NOTICE OF PUBLIC MEETING
CITY OF ALBANY
CITY COUNCIL
 Council Chambers
 333 Broadalbin Street SW
 Wednesday, October 8, 2008
 7:15 p.m.

STAFF REPORT Site Plan Review

TYPE OF APPLICATIONS: SP-12-08: Site Plan Review for construction of a shopping center with six buildings on 25.67 acres of land. Tenants for the buildings have not yet been identified.

Site Plan Review File SP-12-08

LIGHTING SECTION - KEY MAP
HIGHWAY 20 RETAIL CENTER

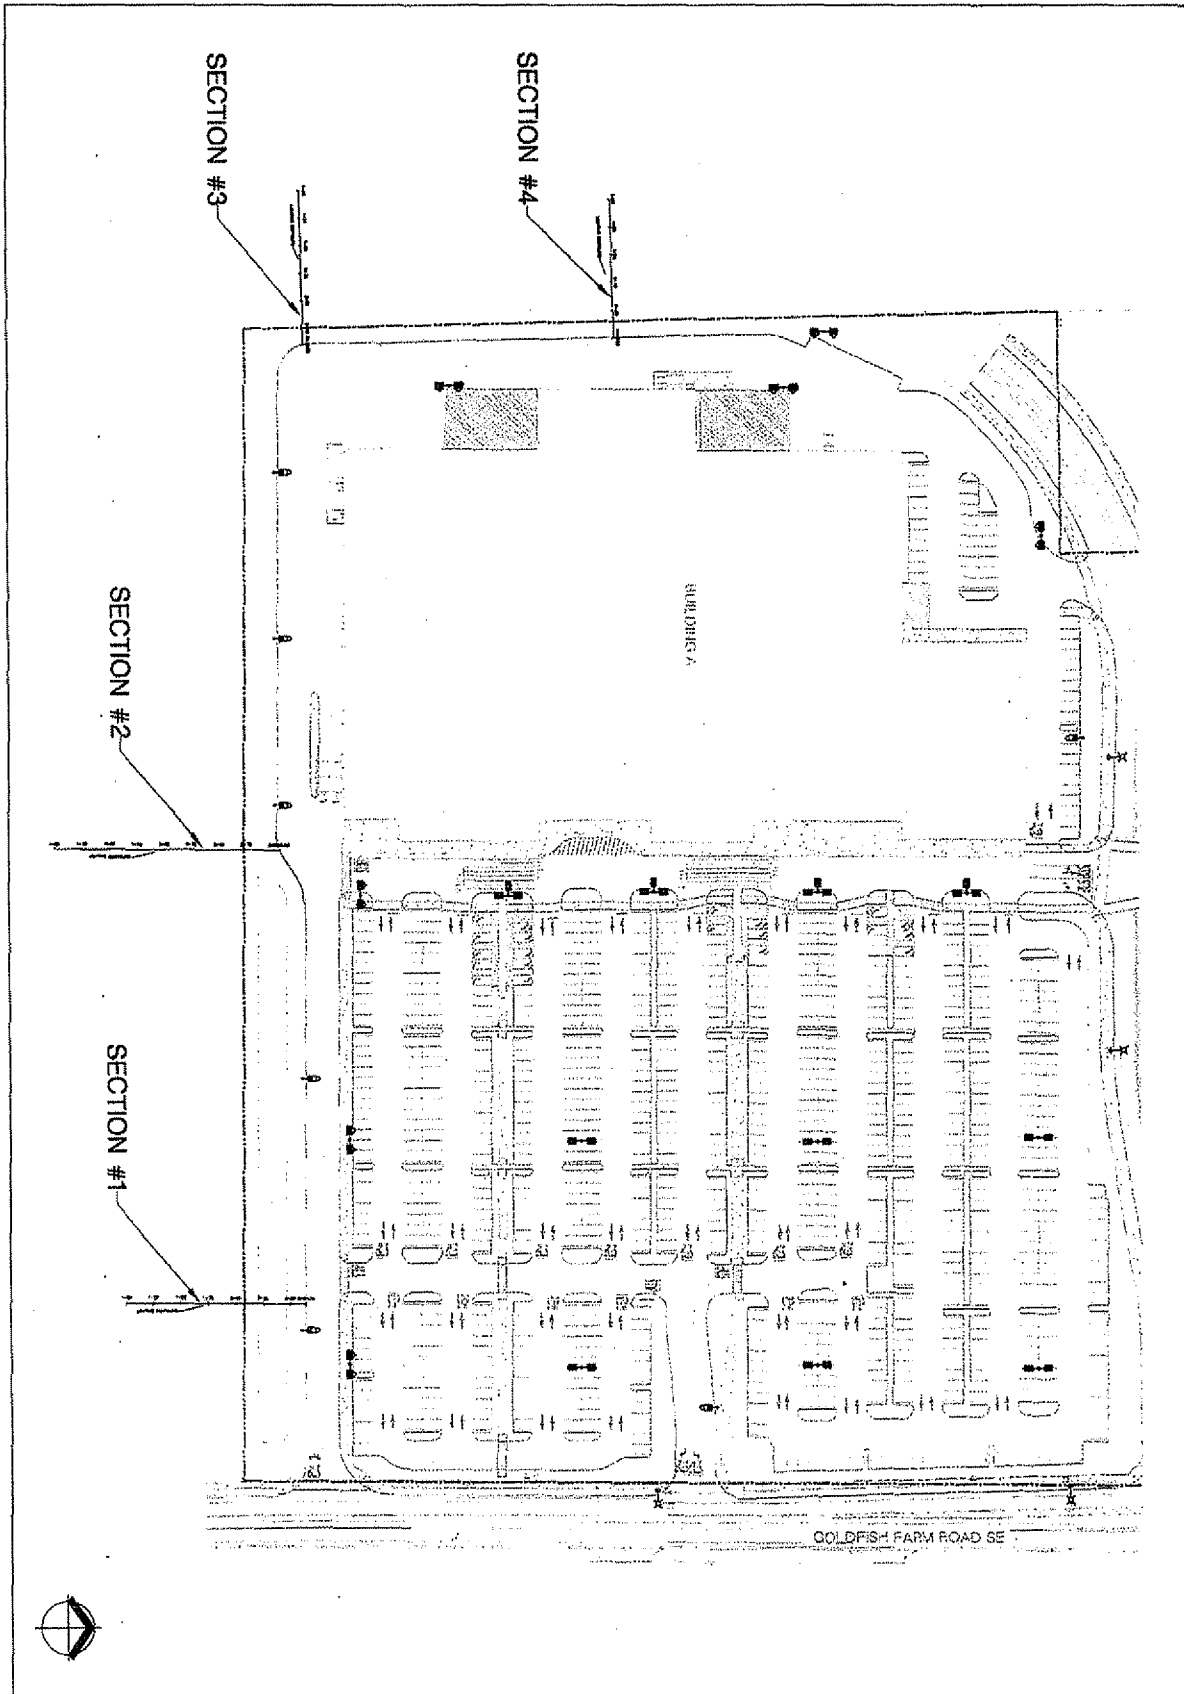
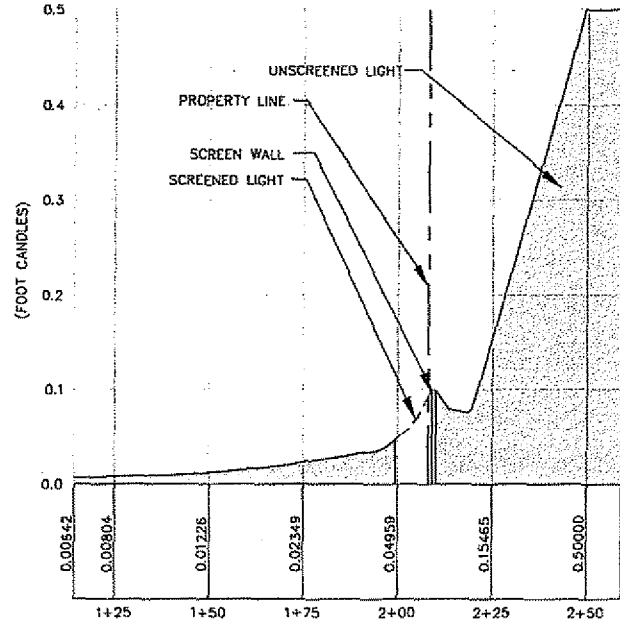
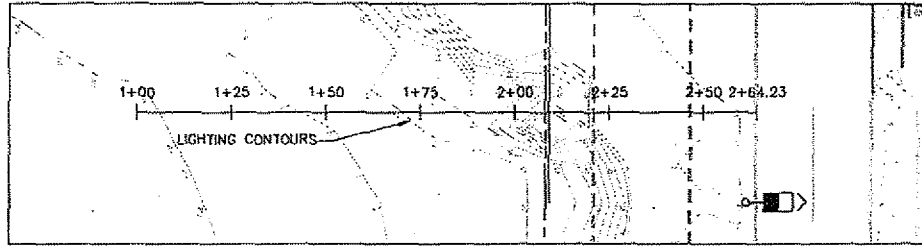
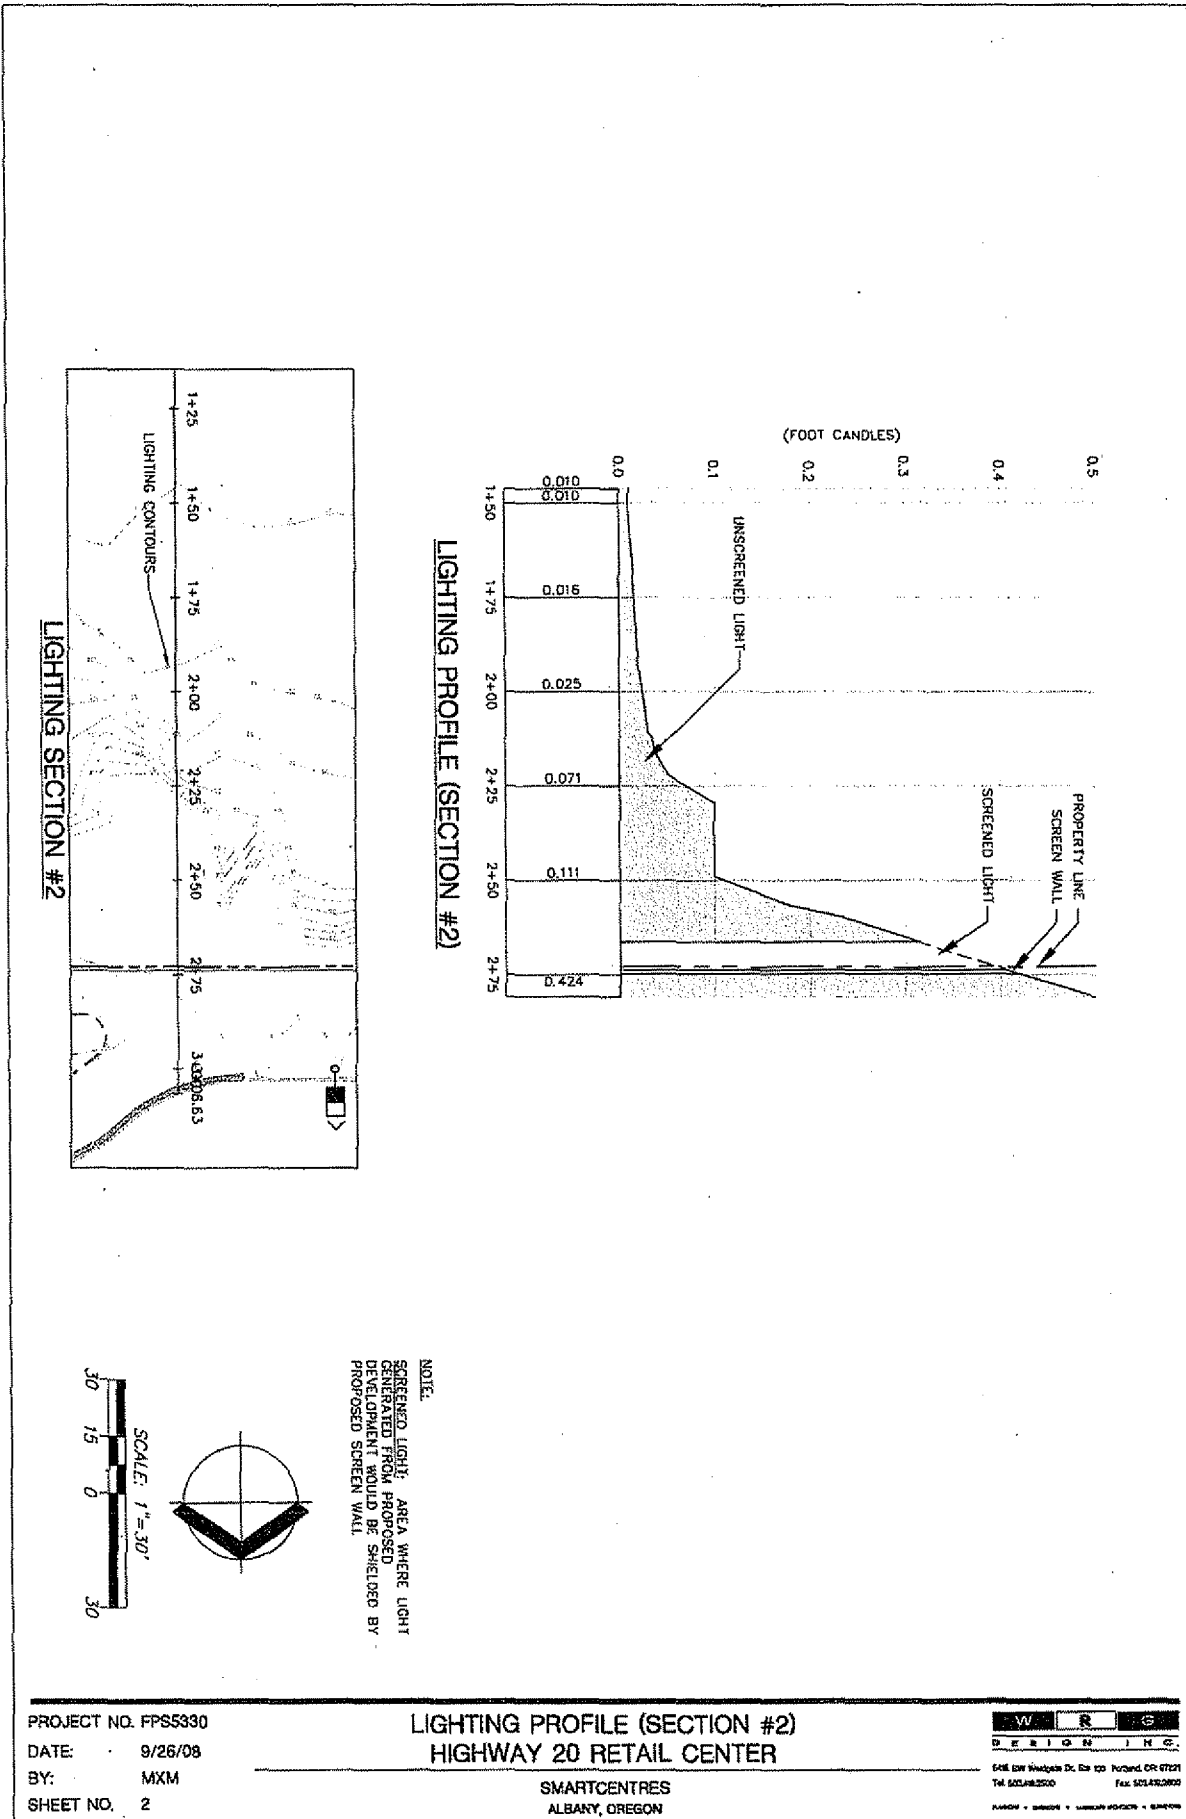
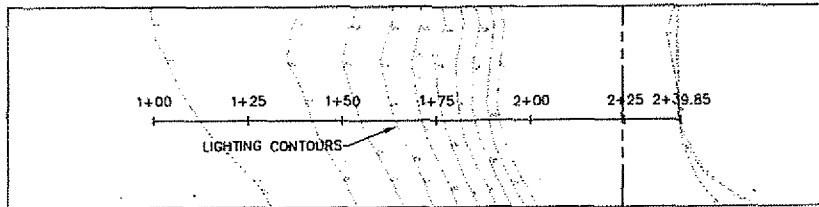
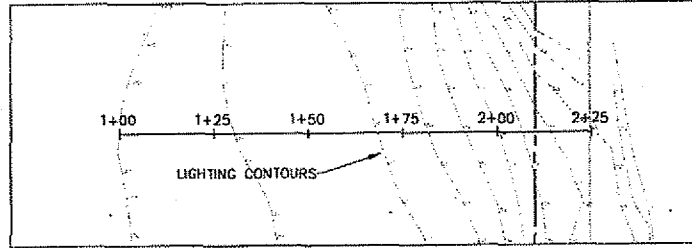
The applicants submitted a lighting plan and detail drawings that show what kind of light fixtures will be used. The lighting plans show that lighting from the shopping center will be arranged so that light shines down toward the ground. This seems to meet the ADC 9.120(4) requirement. The lighting plan and detail drawings show that light will be visible on adjacent properties to the south. The applicants were looking for a numerical standard to show that the light would not exceed the standard. They found the ADC 9.480 standard. This standard does not apply to parking lots, but if it did, the lighting plan meets the standard. The light levels visible on adjacent properties vary from 0 to about 0.3-foot candles, which is less than 0.5-foot candles.

WESTERN PROPERTY LINE CROSS SECTION S-S
NTS

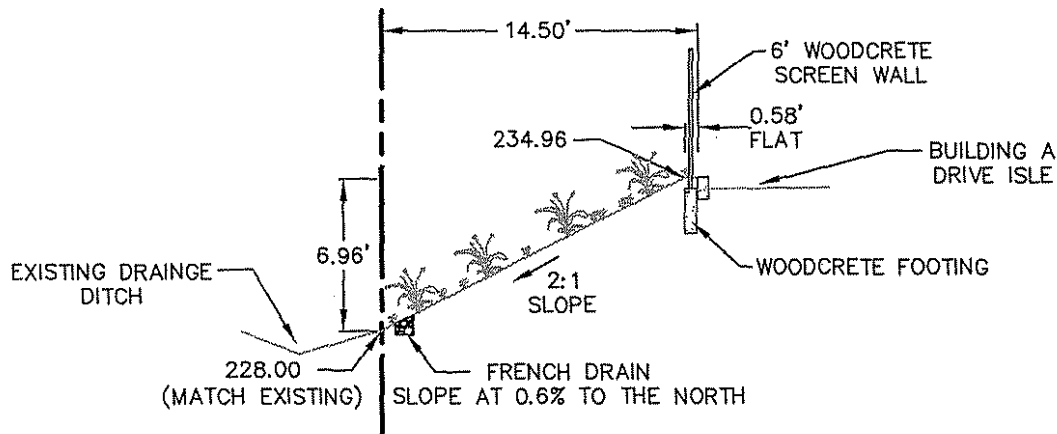
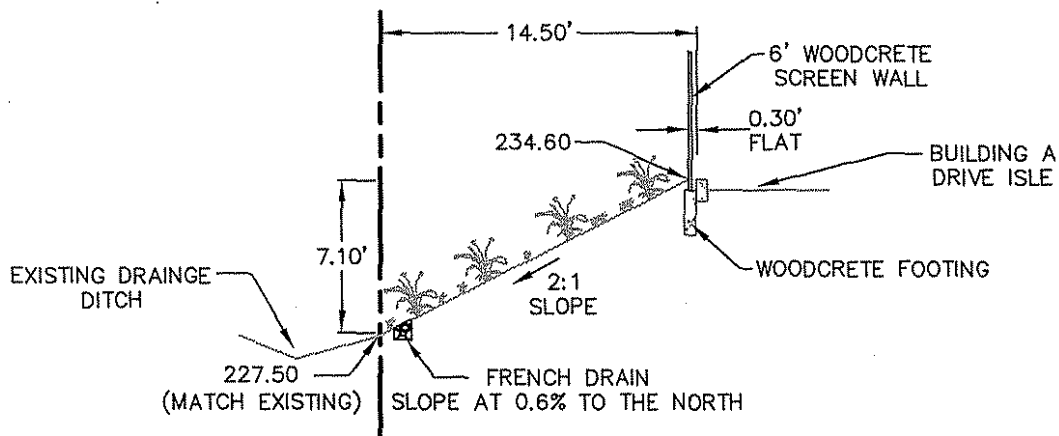
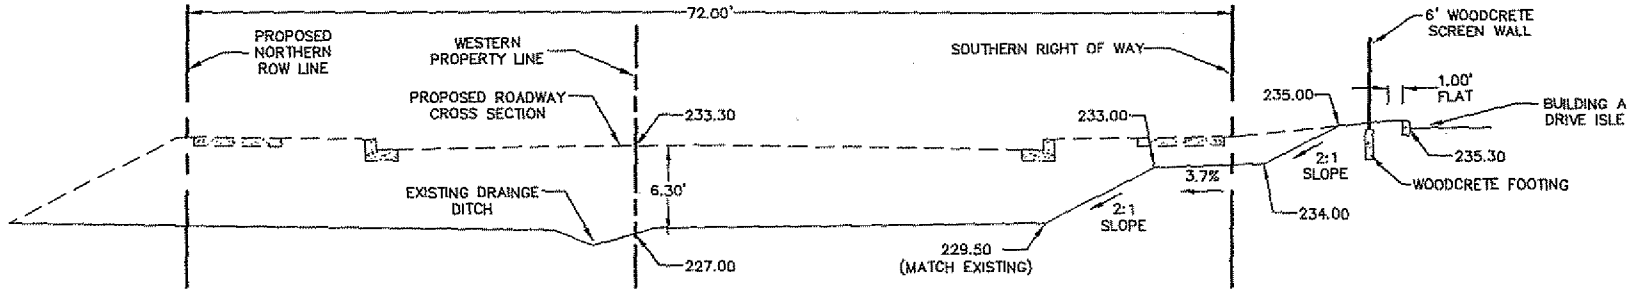
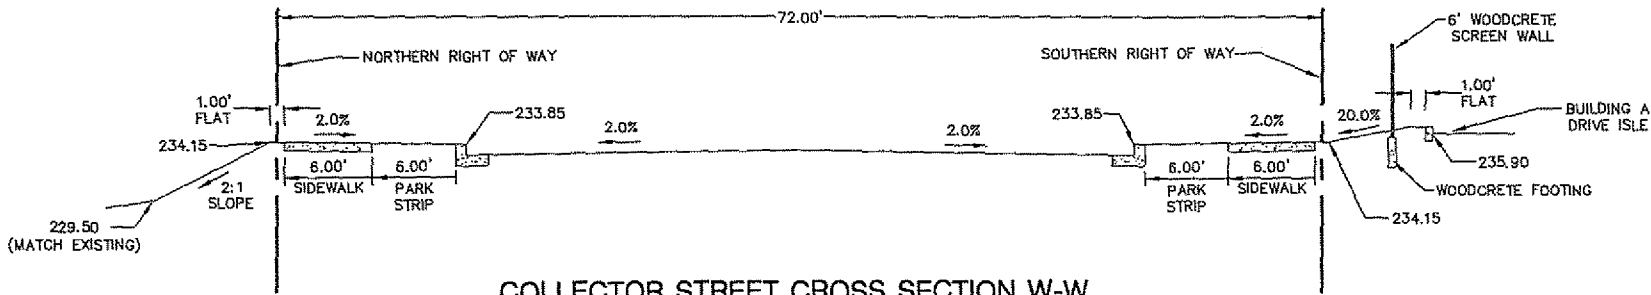
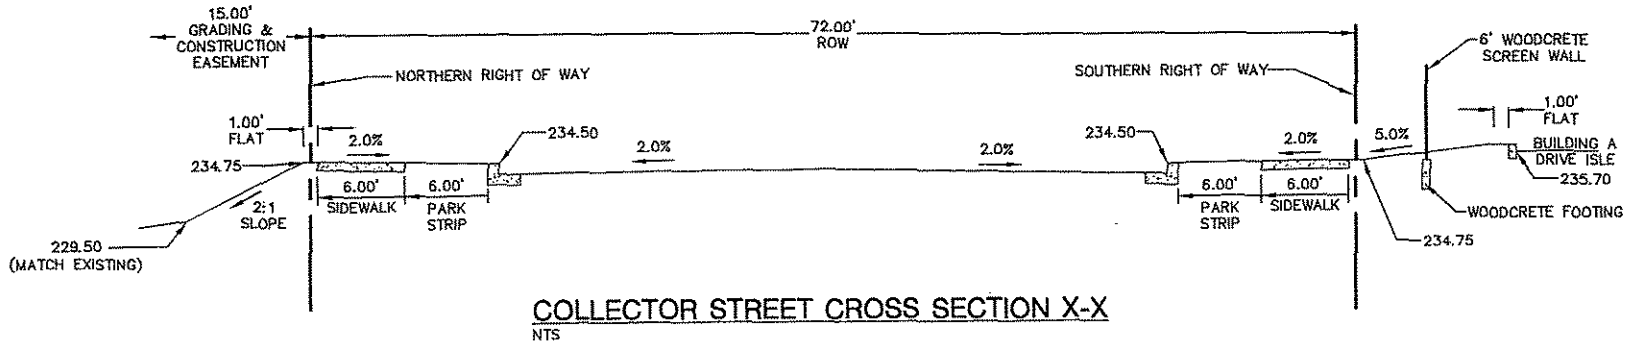
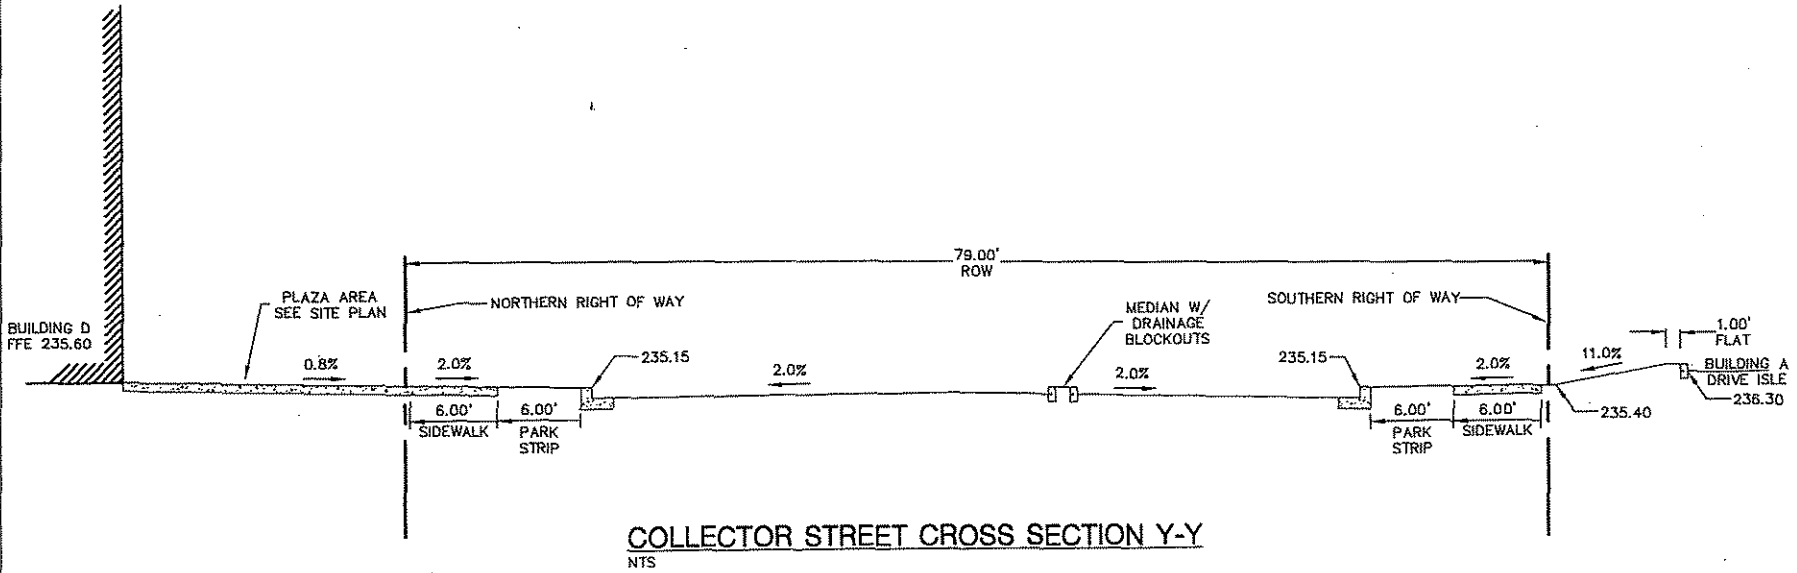
Elevations Along the South and West Property Lines: The elevation of the shopping center property after filling will be higher than some surrounding properties. Staff asked the applicant to provide cross sections that show the elevations along the south and west property lines. We were particularly interested in how the elevations would match along the south property line because there is an existing subdivision and backyards along part of the south property line. Part of the vacant property along the west property will most likely be developed with houses in the future.

Two of the owners of properties to the south asked what will be the impact of the shopping center fill on their drainage. The cross sections submitted by the applicants show that the elevation of the shopping center property along the south property line adjacent to the houses will be about 1.2 feet below the adjacent property at one point and about 2 feet above the adjacent property at another point. The applicants explain that they will provide a footing drain along the south boundary to collect any drainage that now flows toward the wall from the adjacent backyards. This is a condition of approval listed in the staff report. French drains will be provided along the west property line where fill slopes toward the adjacent properties. The drains will collect water before it can flow onto adjacent properties.
